Sierrita Operations
Environment, Land & Water Department
6200 West Duval Mine Road
PO Box 527
Green Valley, Arizona 85622-0527

May 23, 2014

**Re: Response to Comments, Voluntary Remediation
Groundwater Investigation Report Freeport-McMoRan
Sierrita Mine Green Valley, Arizona; Site Code: 100073-03**

Figure 14
2011 Water Levels in Model Domain

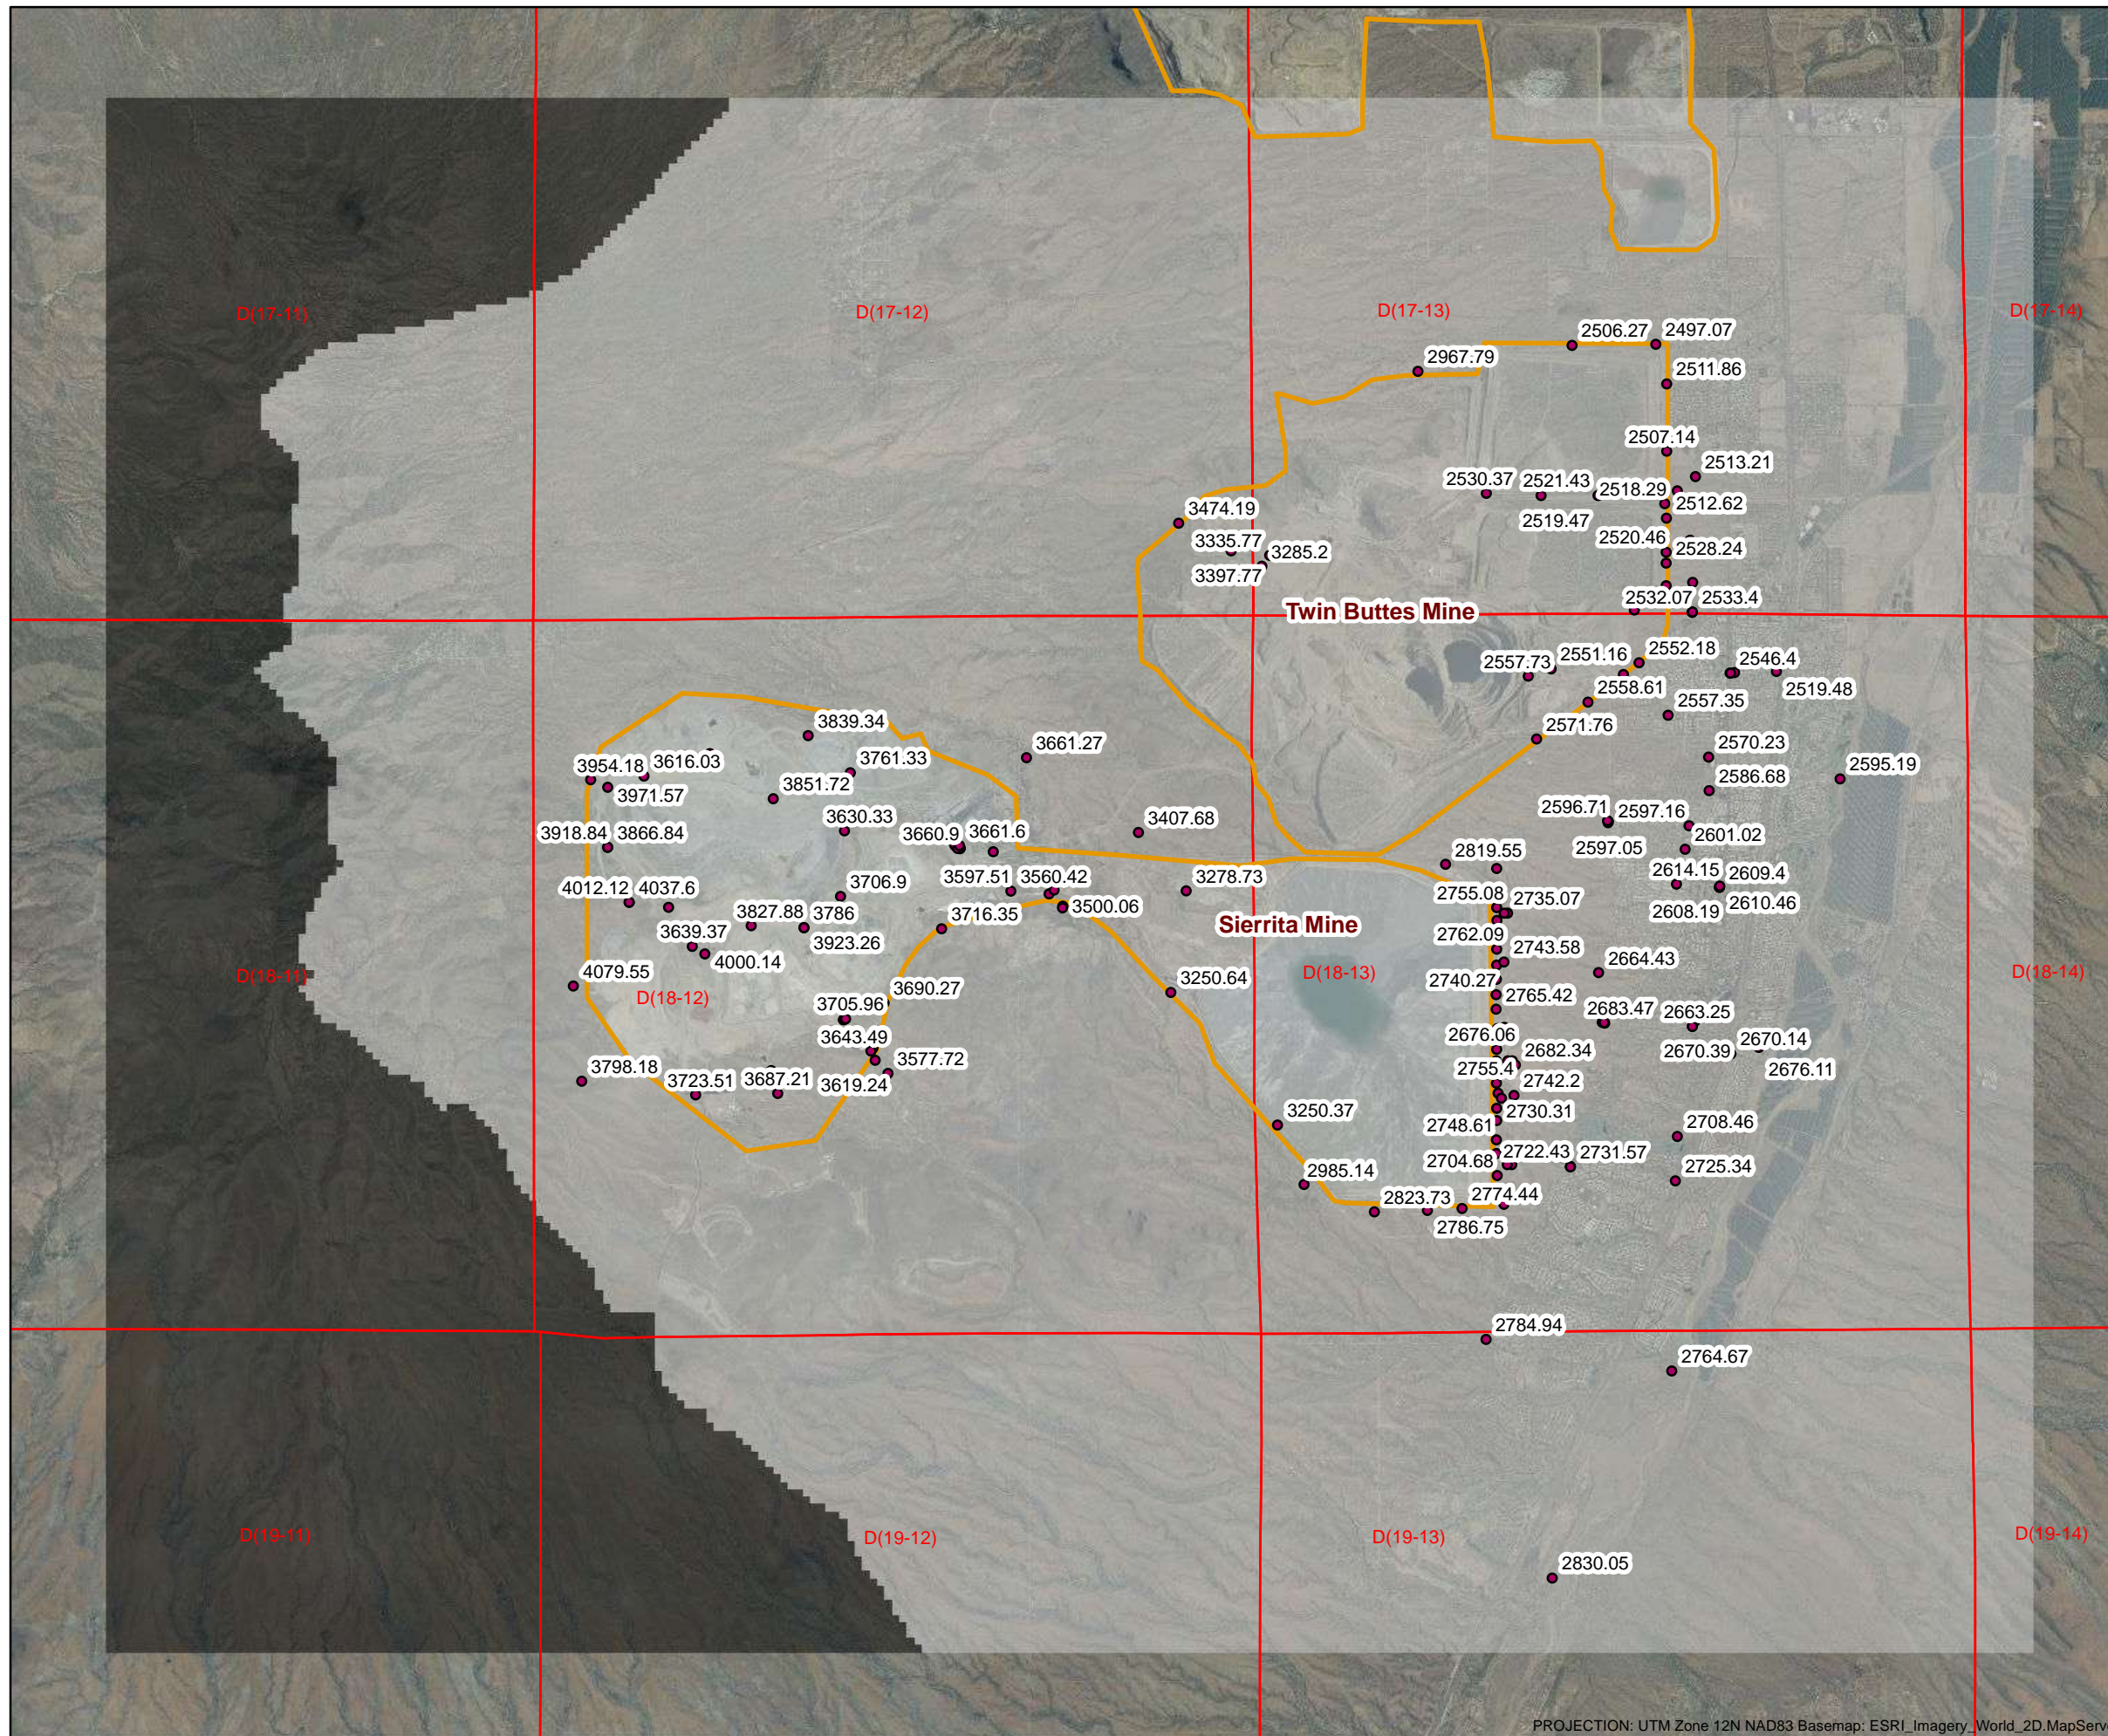
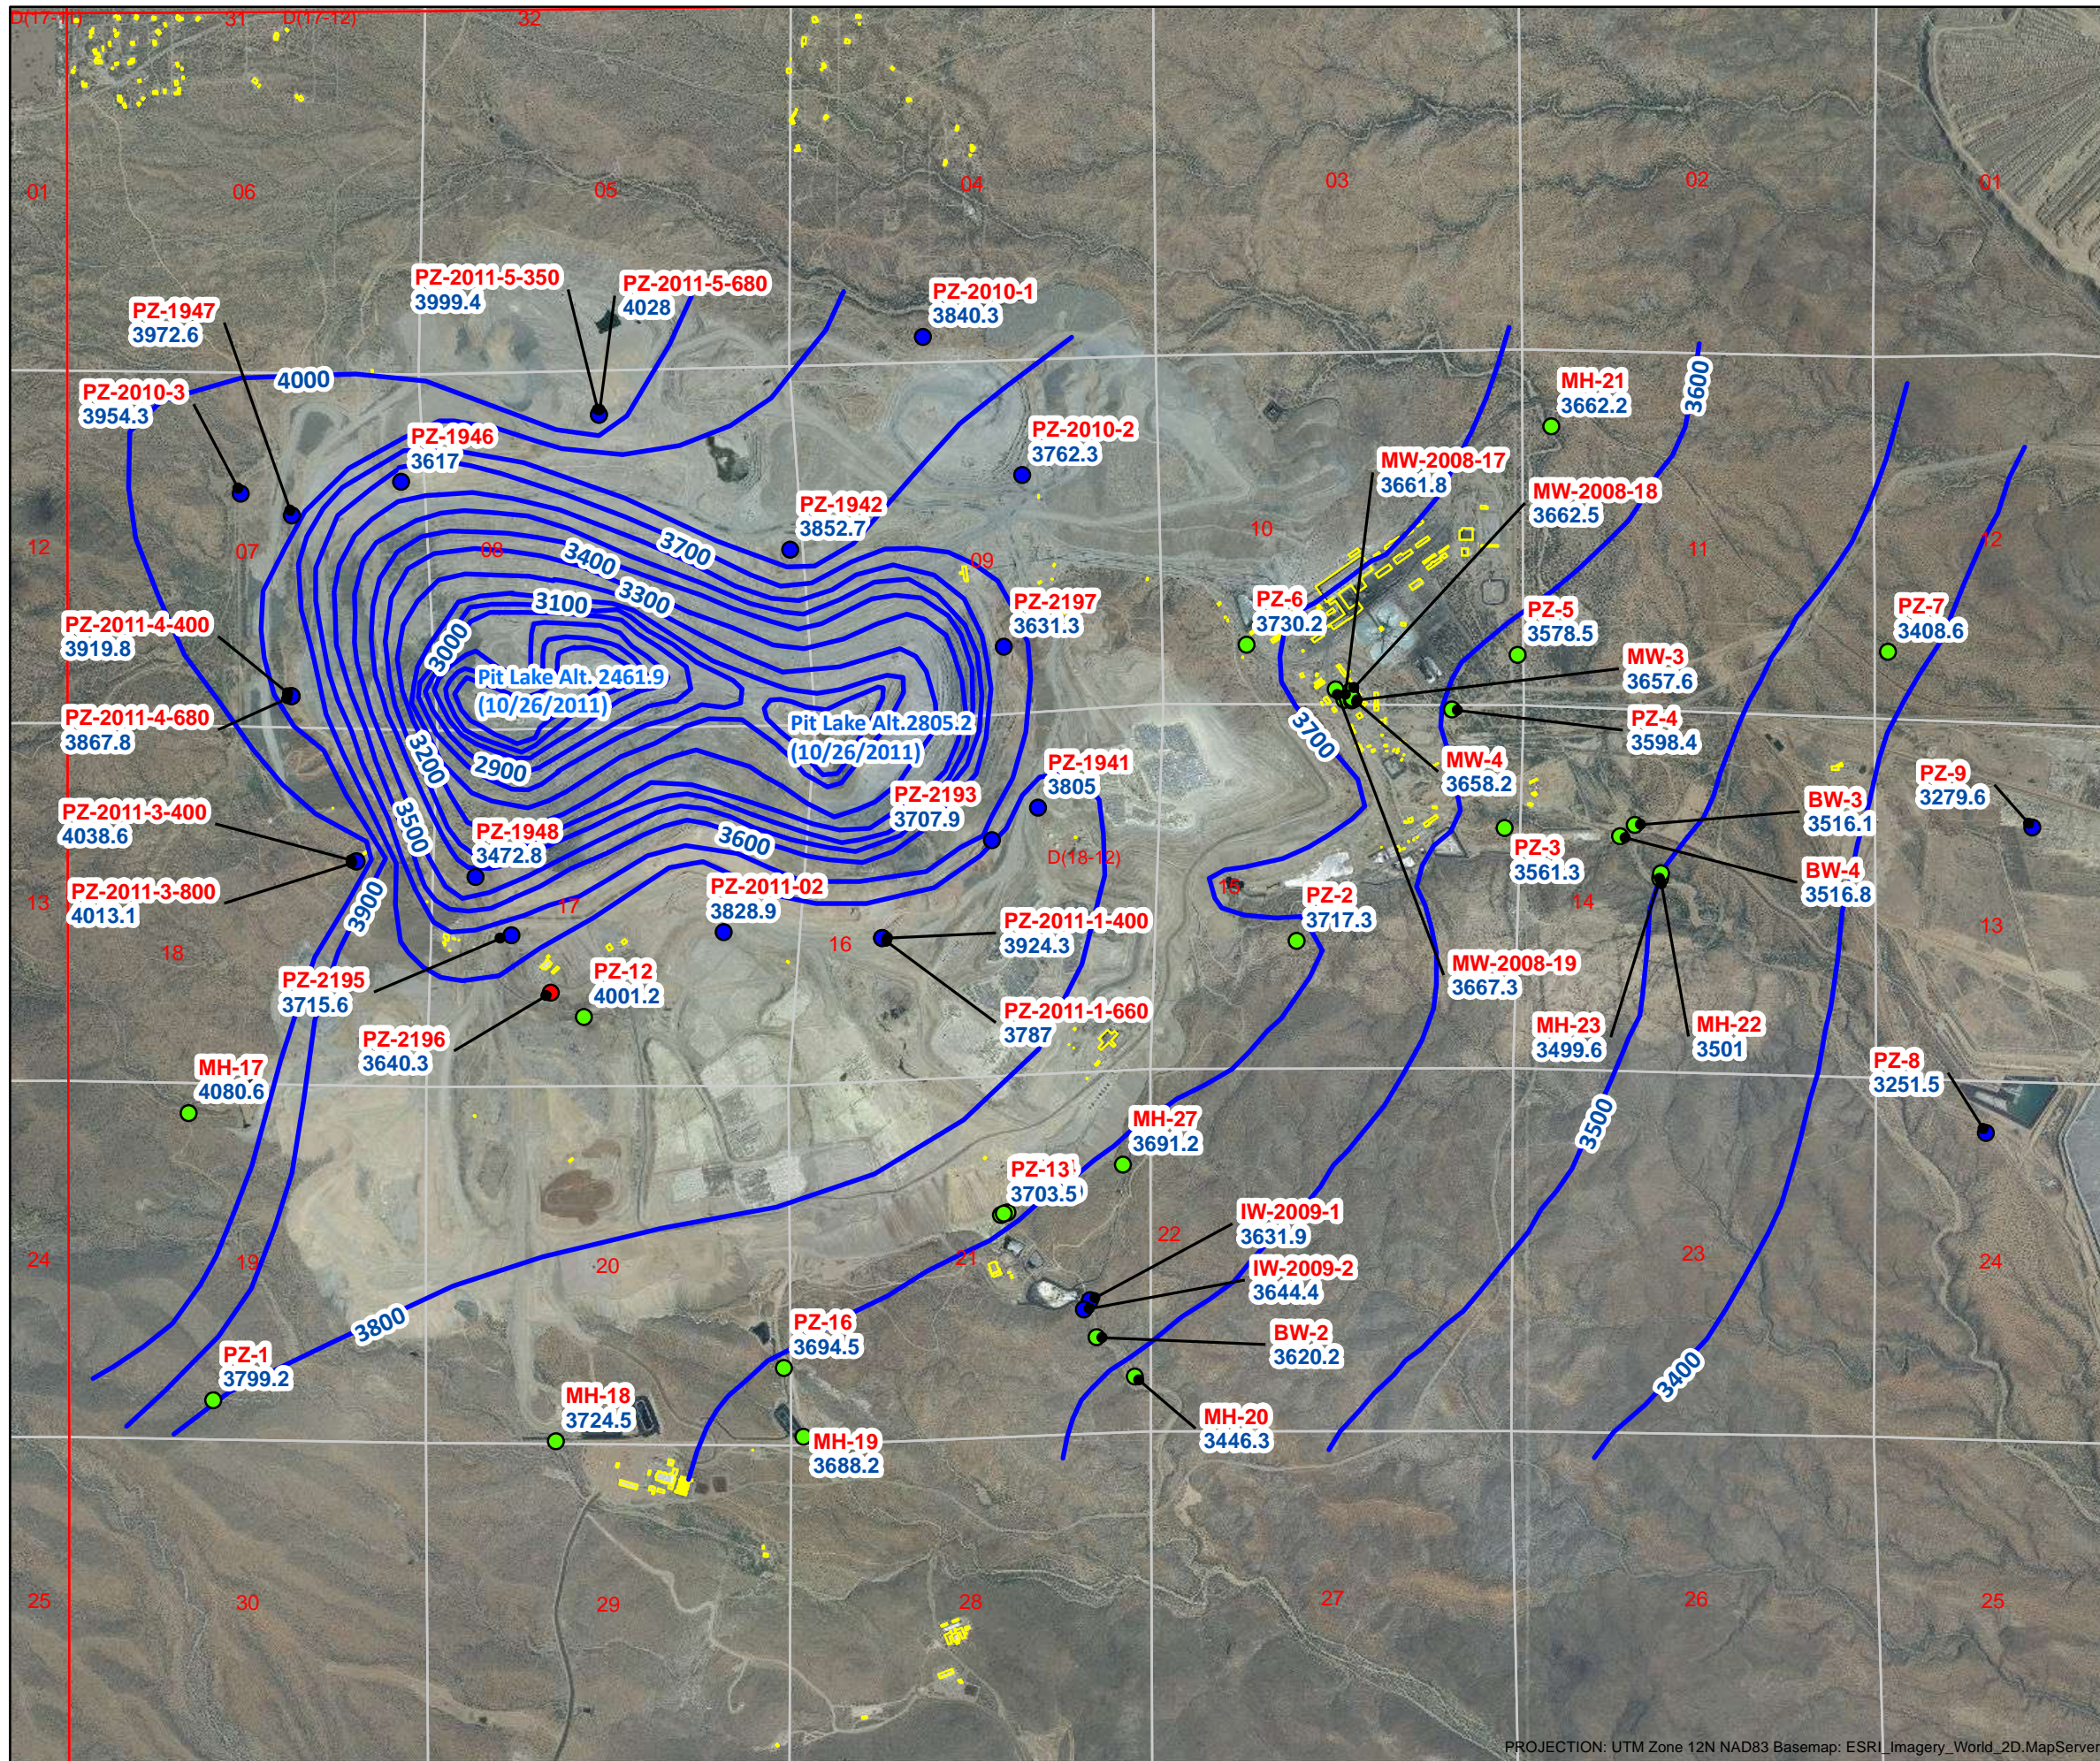
16. **ADEQ Comment:** *Figures 11 through 14: VRP notes that the groundwater contours depicted on the potentiometric maps refer to wells MH-21, MW-2008-12, MW-2008-13, MH-17, MW-2008-14, MW-2008-15, and PZ-01 as "background wells". VRP does not completely agree that these wells are adequate to provide a true representation of background water quality. Only MW-2008-12 is shown to be upgradient of Sierrita mining operations and/or disturbed ground. However, VRP notes that MW-2008-12 could be hydraulically downgradient of the Twin Buttes mine site and therefore may not actually represent true background..*

The hydrology of the Site indicates a southeasterly groundwater flow direction. This is shown by both by the groundwater level data presented in the Report (see Figures 11 through 14 in the Report) and the Sierrita and Twin Buttes Mines Passive Containment Capture Zone Analysis (PCCZ Report), which includes additional monitoring well data both regionally and at the Site. Both hydrogeologic interpretations of well data support the assertion that the wells in the North and West Background Areas are hydrogeologically upgradient of mine activity and disturbances. Additionally, as the PCCZ report indicates, active dewatering of the Sierrita Pit also draws water into the pit itself: as shown, some of the groundwater underneath the West Waste Rock Piles actually flows towards the open pit rather than south-southeast. Figures 13, 14 and 18 from the PCCZ Report are included for reference (see Attachment 3).
